**RESPONSE TO REQUEST FOR INFORMATION (RFI) AND SECTION 50 AMENDMENT**

**Planning Application No:** GE/DP-36420/2023  
**Subject Site:** 139 and 141 Hawthorn Road, Caulfield North  
**Proposal:** Construction of a three storey residential apartment building, a front fence exceeding 1.5m in height (to Halstead St), alter access in a Transport Zone 2 (Hawthorn Rd) and a reduction to the statutory car parking requirements.

*Image 1: Services cupboard colour, height, style (RHS) integrated with solid fence theme for the site (LHS).*

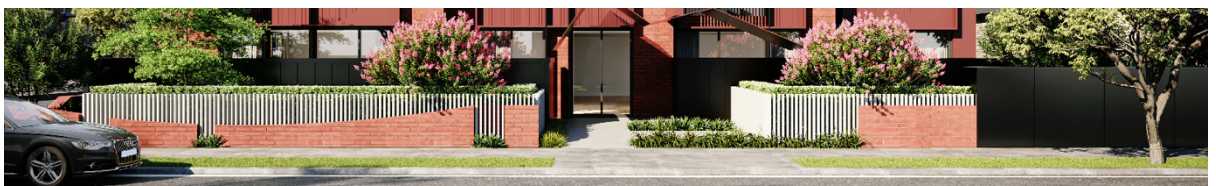
5. The services cupboards fronting Hawthorn Road are a requirement of service authorities. They must be close to/on the primary property frontage. This necessitates their position within the front fence. The material, colour and height of the services are appropriately integrated into the overall fence design. They are positioned off to the side so as to not dominate the site frontage and have the same colour and appearance as the taller fencing set back into the site. It is also part of the fencing theme with similar sections of solid fencing along the Halstead Street frontage (as per the images below).

*Image 2: Services cupboards off to the side do not interrupt the primary frontage, same colour/height as solid fence to edge of POS behind. Open landscaped frontage with low fence is predominant.*

The alternative approach is to maintain a 1.8-1.9m high rendered fence across the full length of Hawthorn Road on the property frontage to give the whole frontage the same appearance as the services cupboards (which would not require a planning permission). However, this would detract from the public realm and existing fencing character to Hawthorn Road.
